Diablo Canyon
Independent
Safety Committee

Public Meeting
February 21 and 22, 2024

Unit 1 Reactor Vessel Embrittlement Update

- DCISC Embrittlement Consultant's Nine Technical Questions of PG&E
- Answers Provided in This Meeting Are Incorporated into Dr. Kirk's Reports to Be Presented Tonight

Embrittlement Prediction (Credibility)

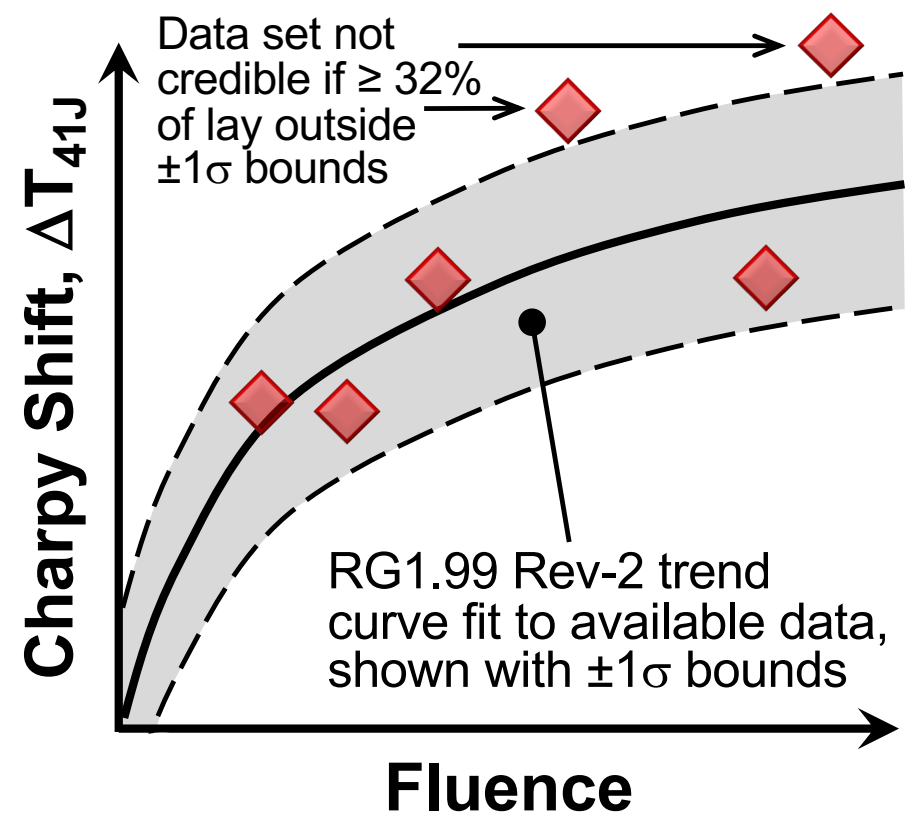
What is credibility?	Credible data follows RG predicted trends
	Not credible data deviates from these trends (see diagram)*

* This is one of RG1.99’s five credibility criteria. Unit 1’s compliance with this criteria has been questioned.

NRC Required Analysis for PTS

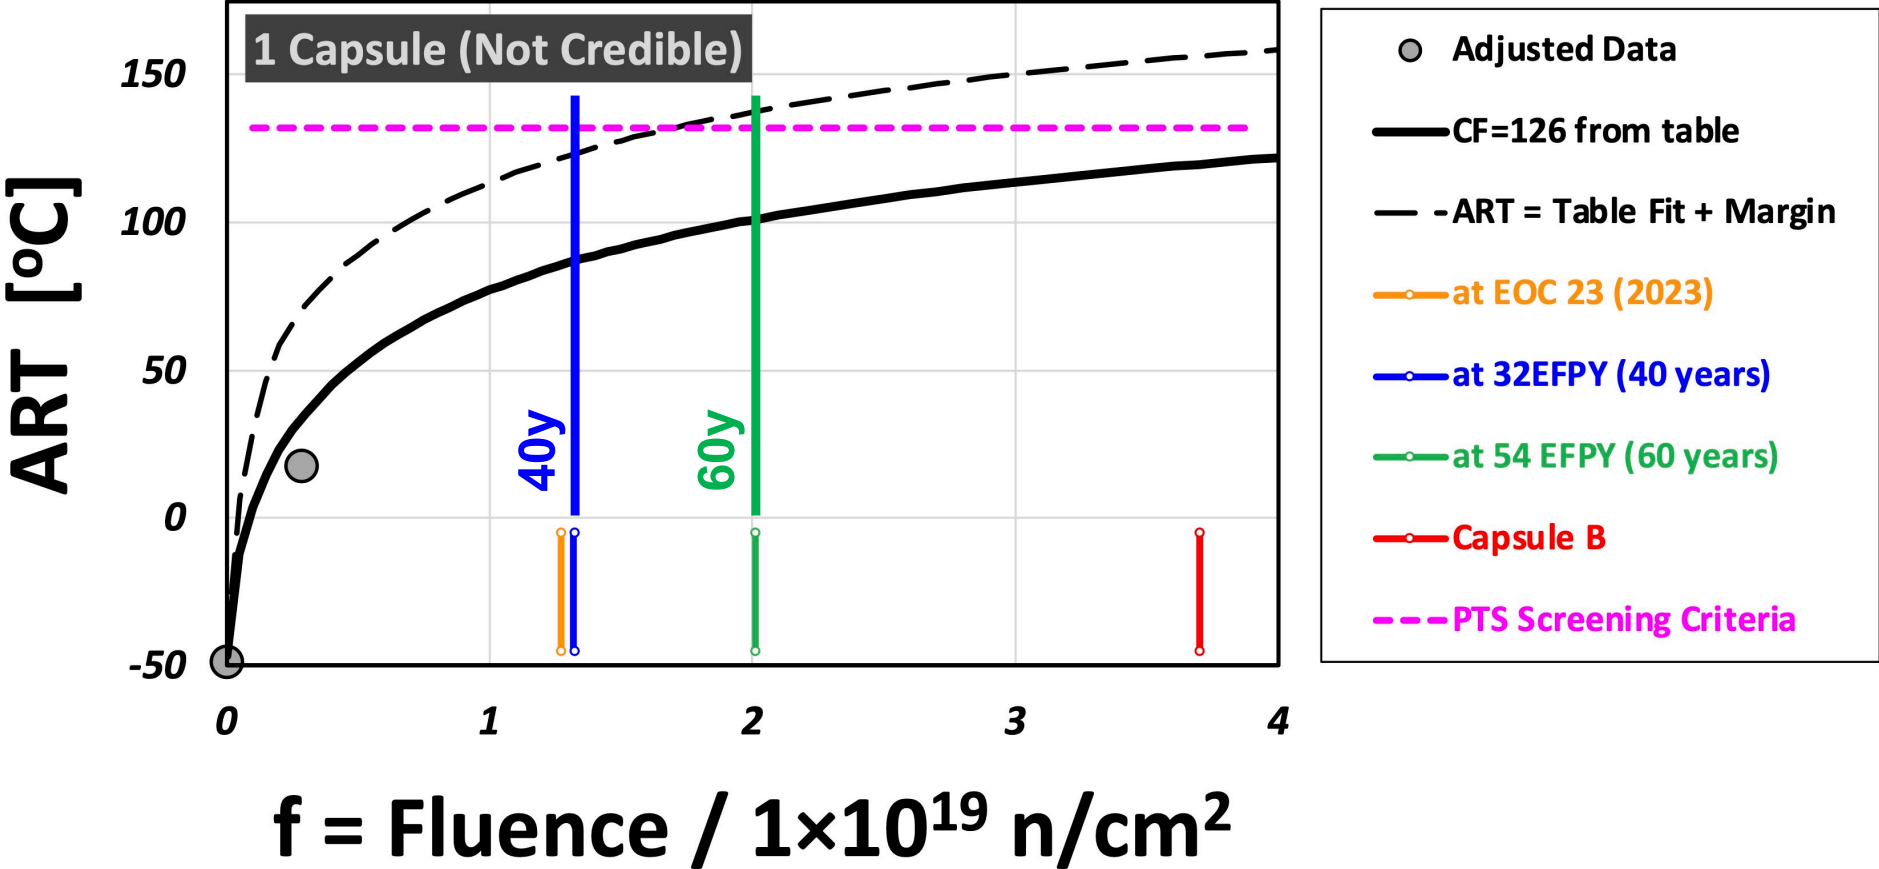
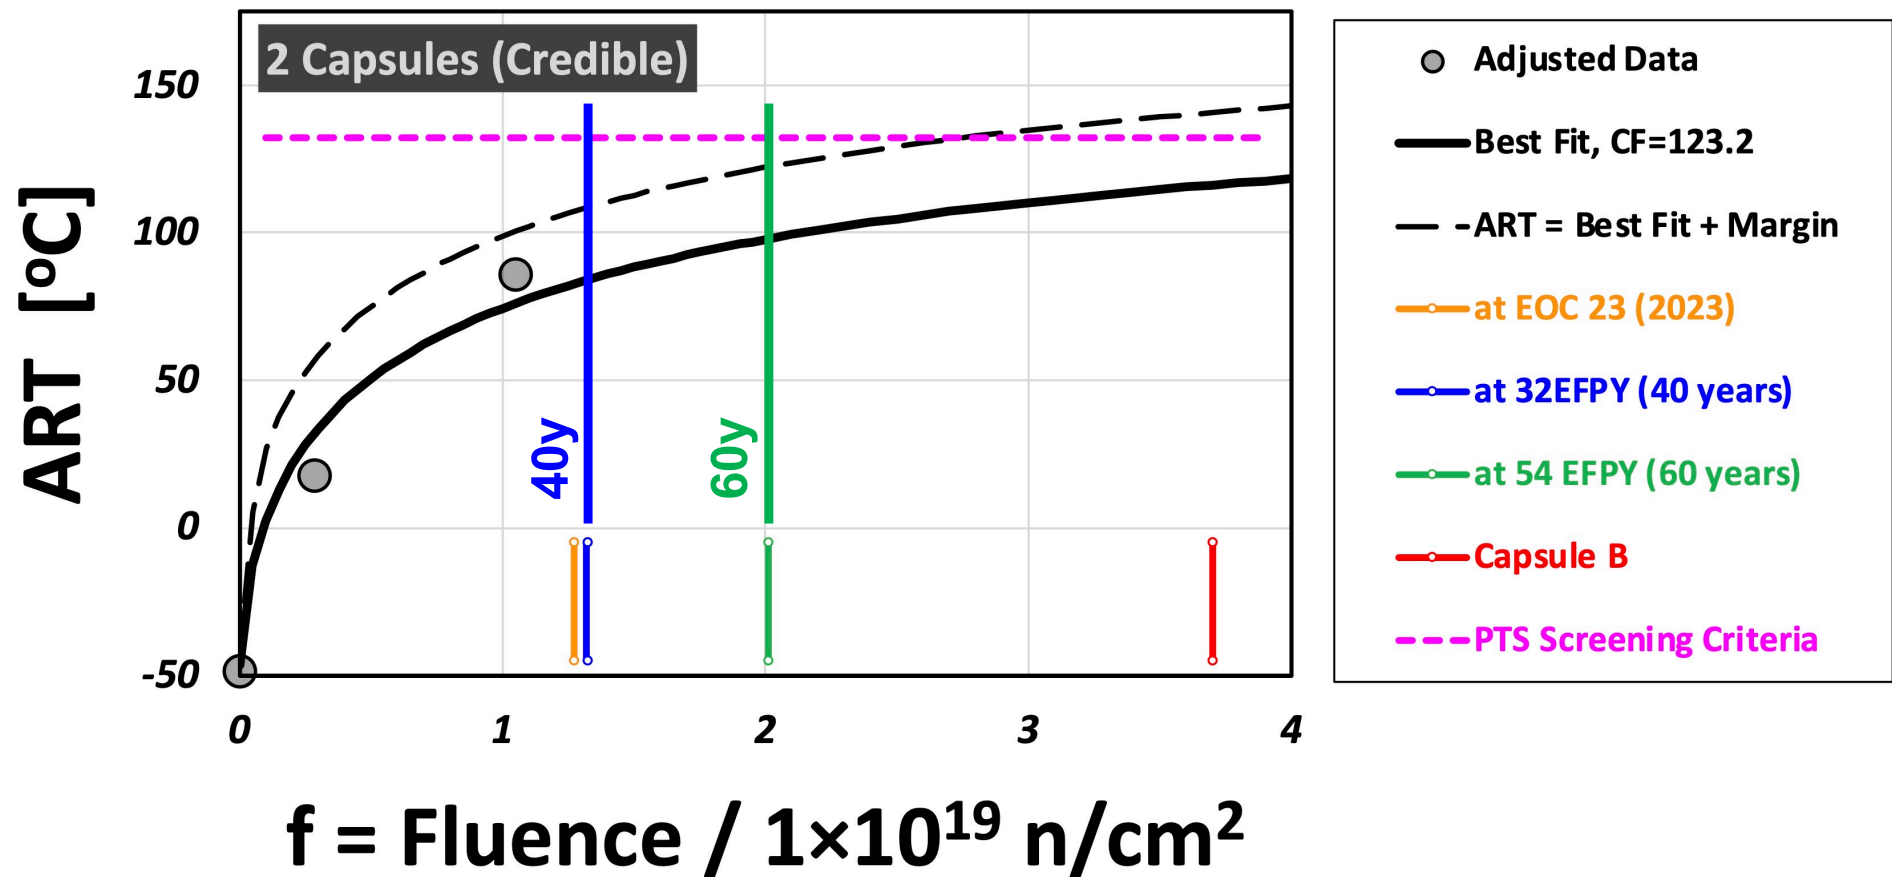
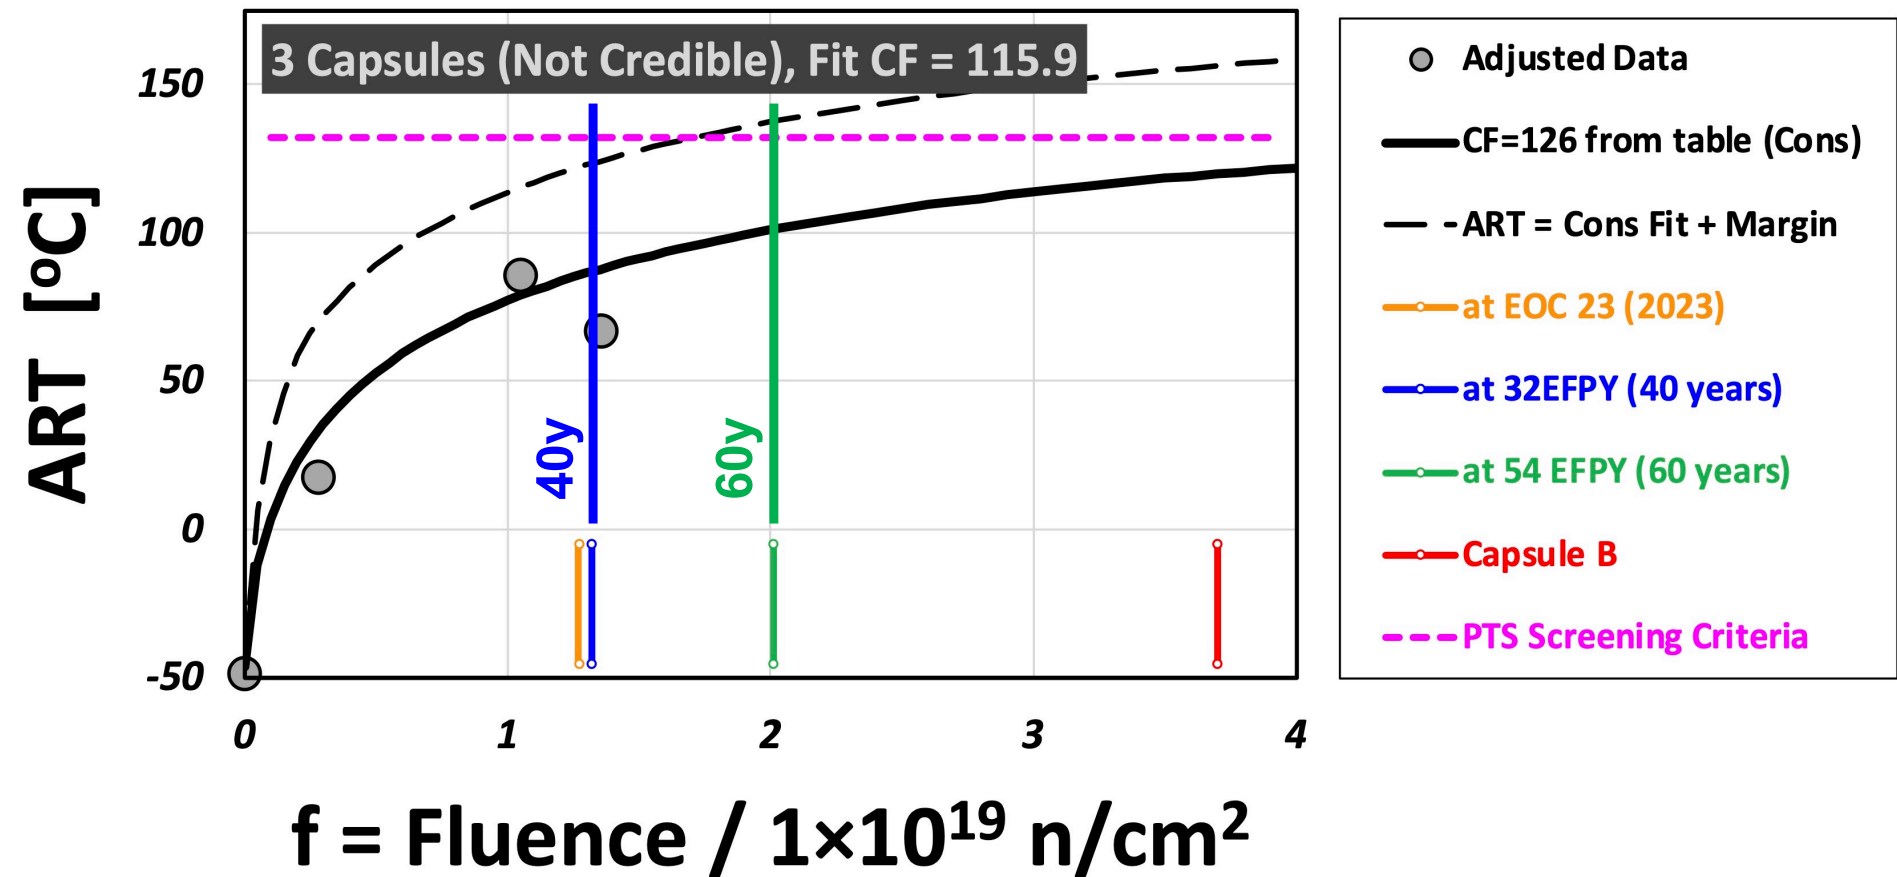
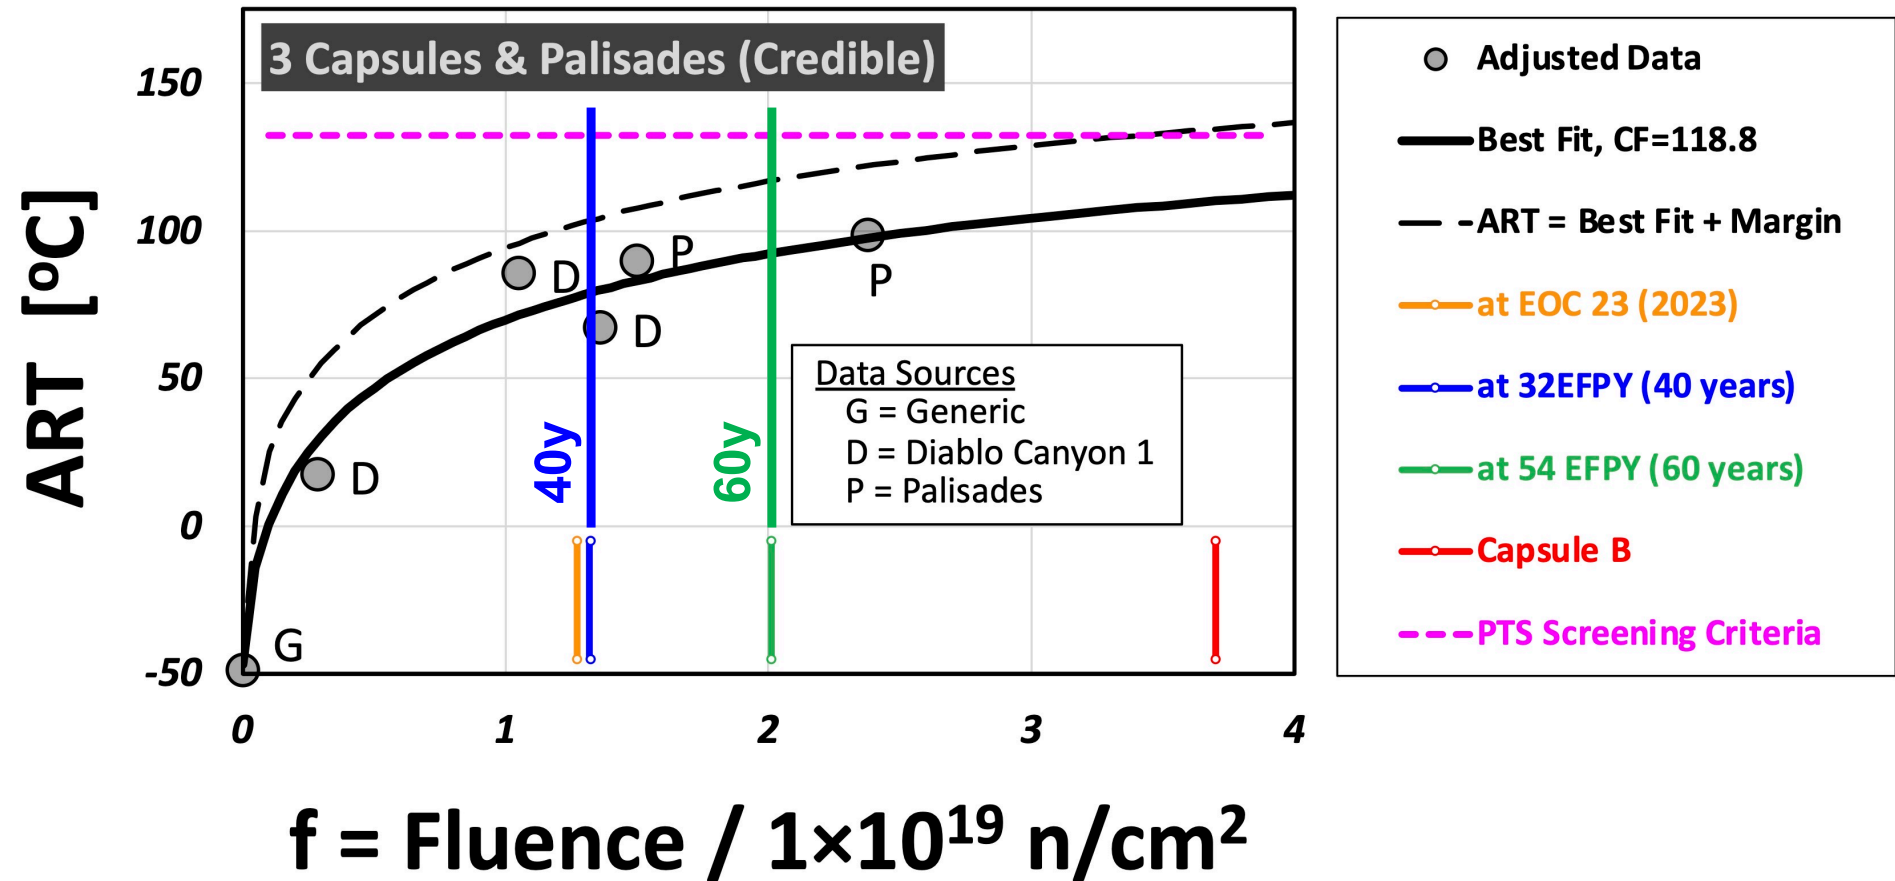
<u>Years</u>	<u>Capsules</u>	<u>Credible?</u>
1985-1987	0	No
1987-1993	1

Enough data & scatter within limits

<u>Years</u>	<u>Capsules</u>	<u>Credible?</u>
1993-2003	2	Yes

Enough data but
scatter exceeds
limits

<u>Years</u>	<u>Capsules</u>	<u>Credible?</u>
2003-2011	3	No

Enough data & scatter within limits

<u>Years</u>	<u>Capsules</u>	<u>Credible?</u>
2011-now	3+Palisades	Yes

NRC Required Analysis for PTS, Summary

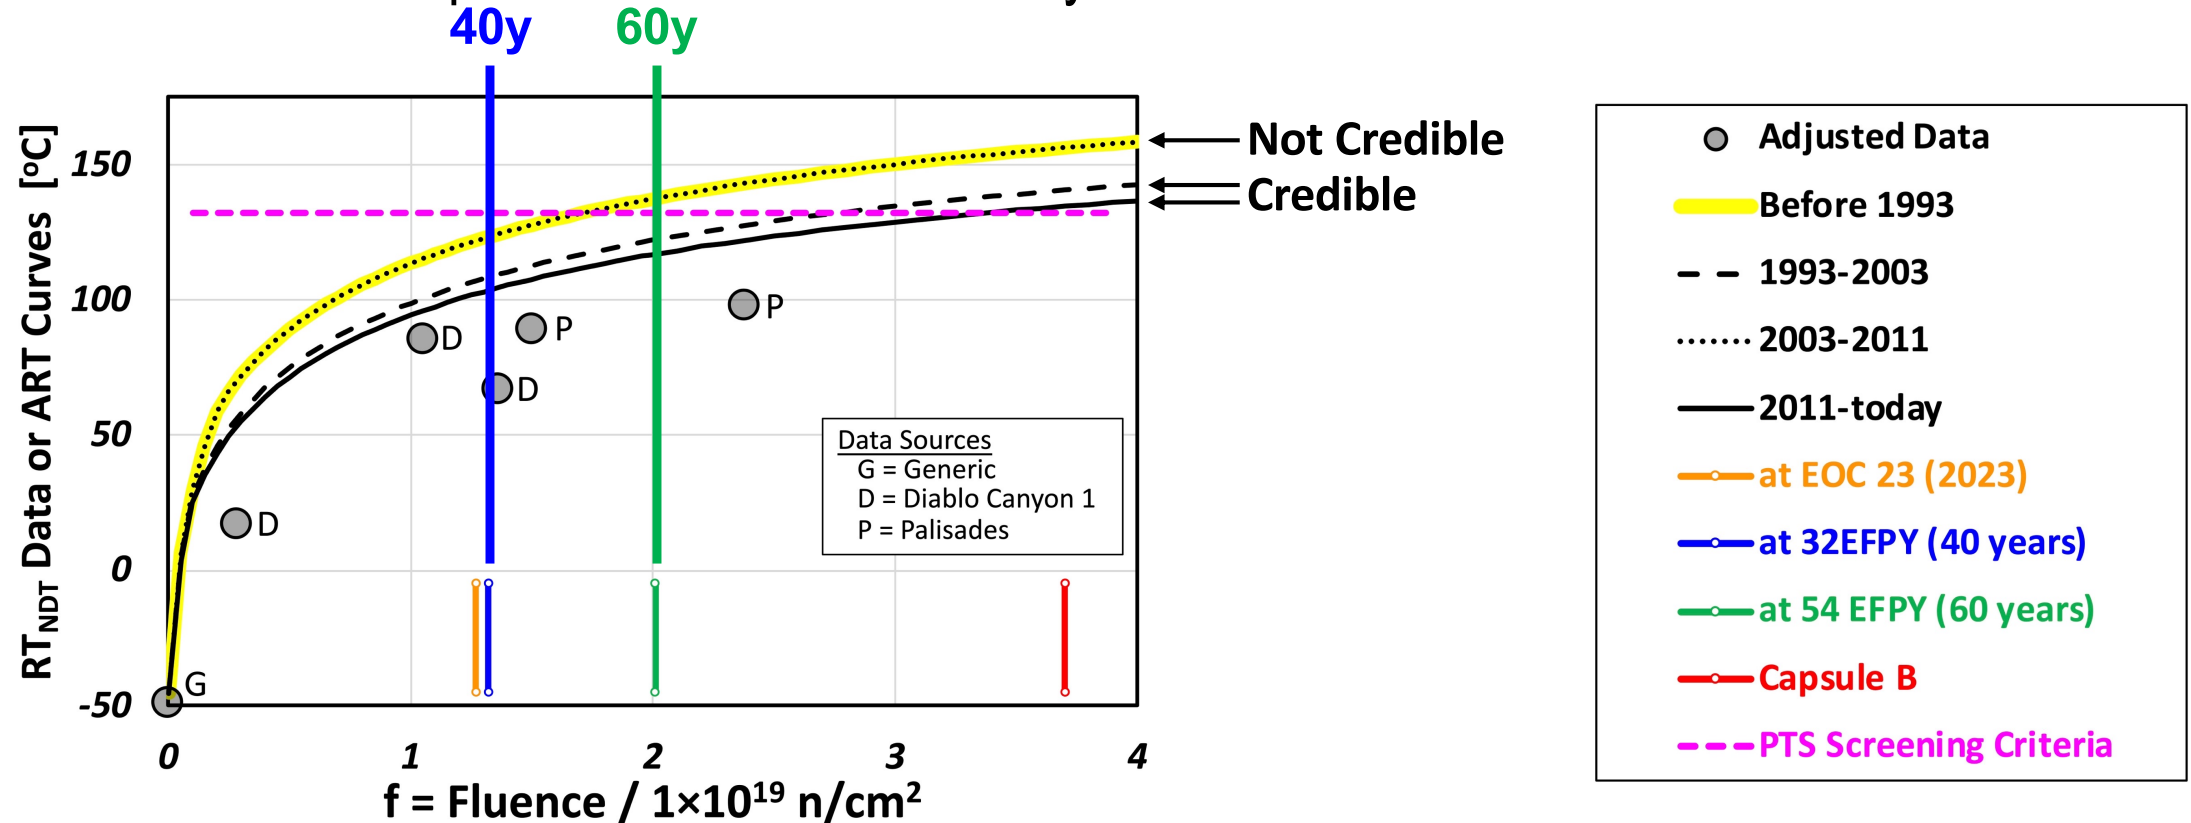
- My calculations fully validate those performed by PG&E, including both estimated reference temperature values and credibility status
 - When **not-credible** the 10CFR50.61 PTS screening criteria is exceeded between 40-60 years due to added conservatism
 - When **credible** the 10CFR50.61 PTS screening criteria is not exceeded until well past 60 years
- The same trend curve represents both Diablo Canyon and Palisades data well
